MEMORANDUM

TO: District of Columbia Board of Zoning Adjustment
FROM: Karen Thomas, Case Manager
JL Joel Lawson, Associate Director Development Review
DATE: June 14, 2016
SUBJECT: BZA 19297- 3000 M Street N.W.

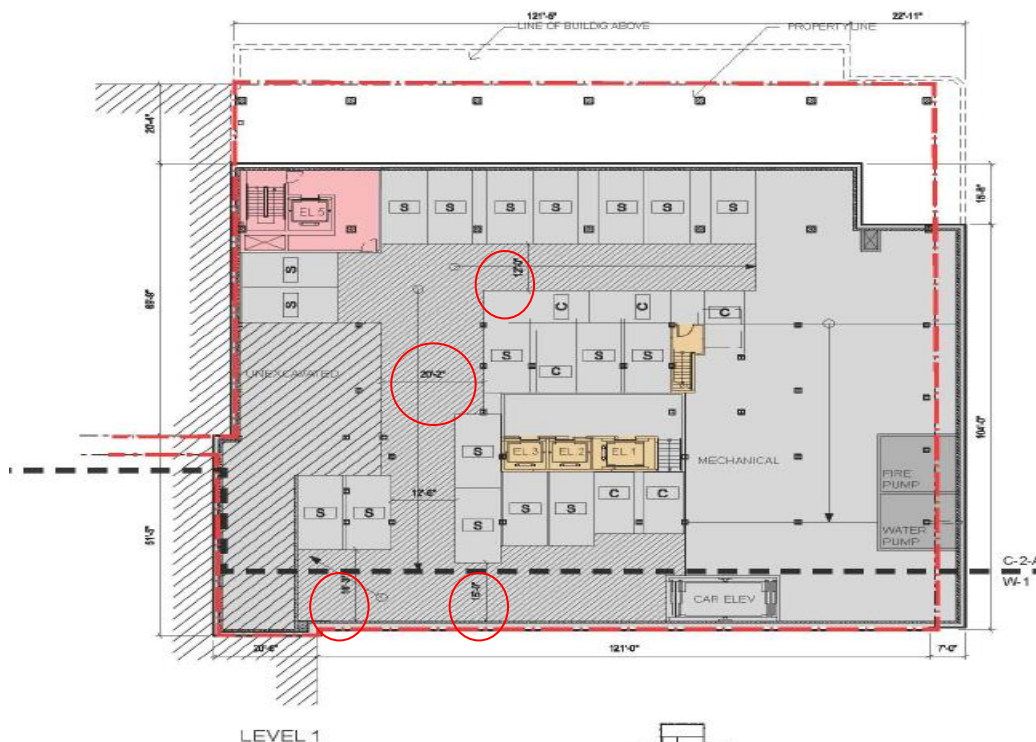
Eighteen (18) standard size spaces and six (6) compact spaces would be provided. A standard size requires a minimum of 9 feet in width and 19 feet in length and a compact car parking space shall be a minimum of 8 feet in width and 16 feet in length (exclusive of drive aisles ramps and columns) (§§ 2115.1, 2115.3).

§§ 2117.5 and 2117.6 requires aisle widths of twenty (20) feet for ninety (90) degree angle parking for both standard and compact parking spaces. The submitted plan (Exhibit 7, Page A18, reproduced above) shows variable aisle widths of 12 feet, 15 feet, 18 feet 3 inches and 20 feet 2 inches. Similar space constraints noted prior would only permit the most efficient number of spaces that could be reasonably accommodated within the given area, in a measured combination among drive aisle widths, standard and compact-sized spaces.

Section 2115.11 provides for a waiver from §§2115.1, 2115.3, 2117.5 and 2117.6 provided that the parking is managed during a specified 12-hour peak period, to be determined by DDOT, by employed attendants who park the vehicles using the parking facility.

Vehicles would only be valet parked on this site during a 24-hour period. Therefore there should be no harm to the Regulations due to the reduced sizes of the parking spaces and the drive aisle widths.
